**6F50/6F55 TRANSMISSION—SLUGGISH
ACCELERATION FROM 0-8 KM/H (0-5 MPH)
FOLLOWED BY A HARSH BUMP OR A SLIP ON
TAKE-OFF FOLLOWED BY A BUMP—BUILT ON OR
BEFORE 4/15/2011**

TSB 11-12-10

This article supersedes TSB 11-9-11 to update the Service Procedure.

Figure 1 - Article 11-12-10

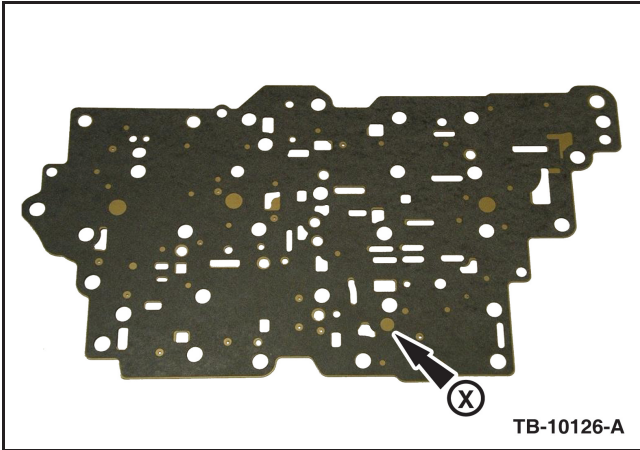
There is a new calibration and transmission valve body change to correct this condition. The valve body change was to delete one hole in the valve body separator plate and remove one check ball from the valve body in the same area where the hole in the separator plate was deleted.

1. For all model years except 2009, proceed to Step 2. For 2009 model year vehicles, verify the transmission dipstick has MERCON® LV listed on the dipstick.
 - a. Yes - The dipstick has MERCON® LV listed on the dipstick; proceed to Step 2.
 - b. No - The dipstick does not have MERCON® LV listed on the dipstick; this procedure does not apply. Follow normal Workshop Manual diagnostics.
2. Reprogram the PCM to the latest calibration using IDS release 73.04 and higher. This new calibration is not included in the VCM 2011.5 DVD. Calibration files may also be obtained at www.motorcraft.com.
3. Remove the transmission valve body. Refer to the Workshop Manual (WSM), Section 307-01.
4. Replace both separator plates listed in the Parts List. The X identifies the hole in the valve body separator plate which will be eliminated. (Figure 1)

Figure 2 - Article 11-12-10

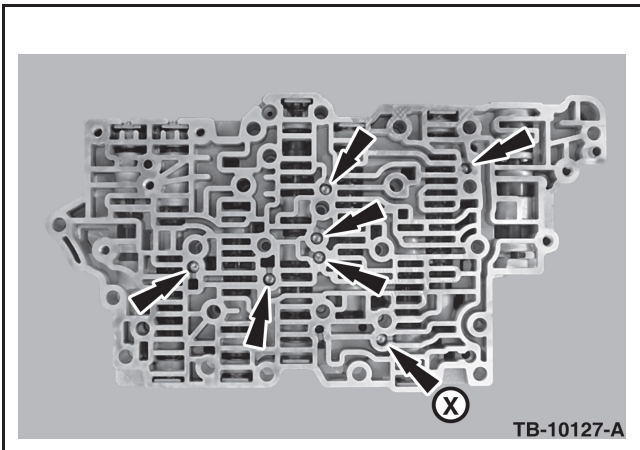
5. Remove one (1) check ball identified as X. (Figure 2)

- a. Proper check ball locations on the remaining six (6) valve body check balls shown with arrows. (Figure 2)
6. Install transmission valve body. Refer to WSM, Section 307-01.
